EAGLE MOUNTAIN CITY

City Council Staff Report

Project: Gotta Dance Studios – Dance Studio
Applicant: Scot Hazard
Request: Site Plan
Type of Action: Action Item

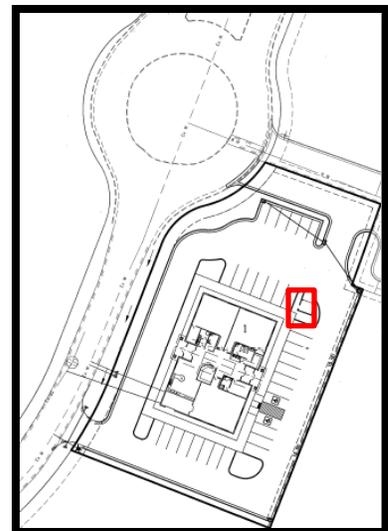
- **Refuse Location:** The applicant has shown a proposed refuse location, in an appropriate location (shown right).
- **Lighting:** The applicant has indicated they have no concerns with the lighting ordinance, and will provide spec sheets when they apply for building permits.

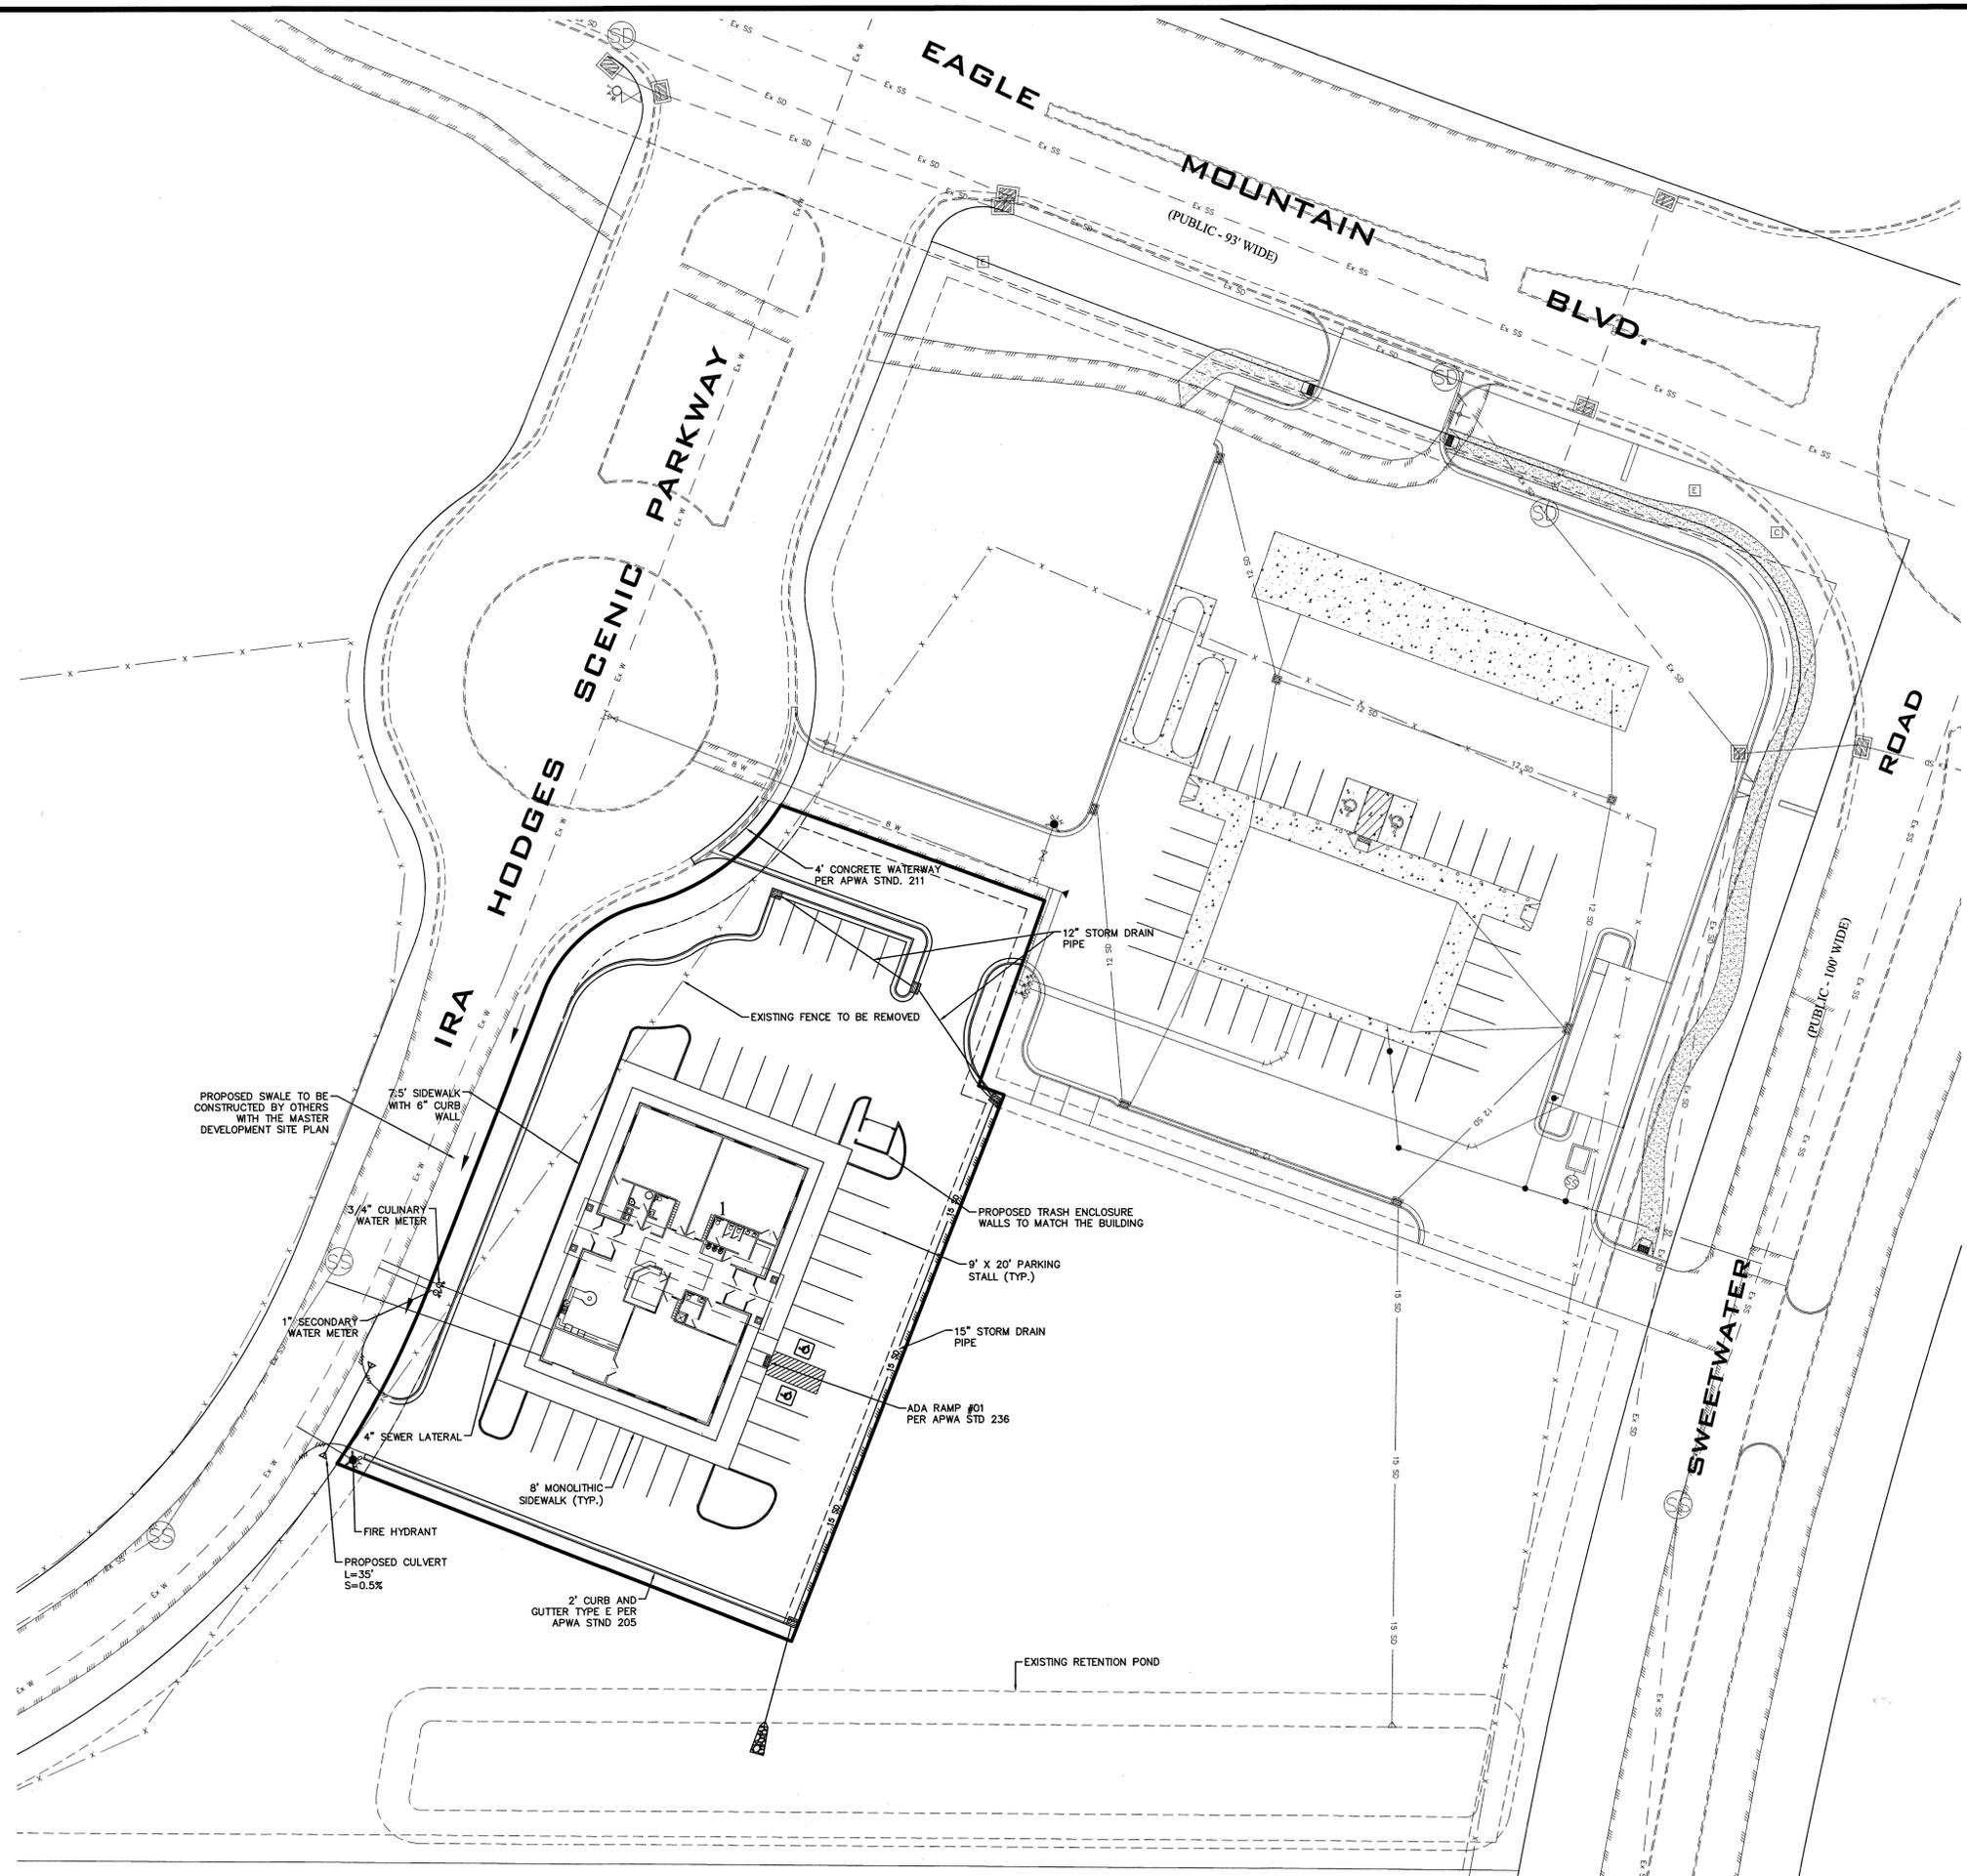
Master Site Plan: The applicant is proposing the Dance Studio within a larger commercial property (**City Center Commercial Project**), due to the size of the property a Master Site Plan is required. The applicant does not own the property, and is intending to purchase the ground for the Dance Studio from the City Center Commercial property owner.

Building permits should not be issued until a Master Site Plan for the City Center Commercial development is approved, and a Final Plat for the *Gotta Dance Studio* is approved by the Development Review Committee and recorded with Utah County.

Staff did receive a Master Site Plan application, but the property owner has asked that the Master Site Plan be removed from scheduled meetings and has indicated they do not wish to complete a Master Site Plan. The property owner has been made aware that failure to complete a master site plan will hold this project up.

The applicant has applied for a Final Plat, and was unaware that the Master Site Plan had been pulled. Staff has reviewed the Final Plat, and has informed the applicant that a Final Plat may not be approved until a Master Site Plan or a Preliminary Plat has received approval from the City Council, as such, the Final Plat is currently on hold pending an approval of the Master Site Plan.
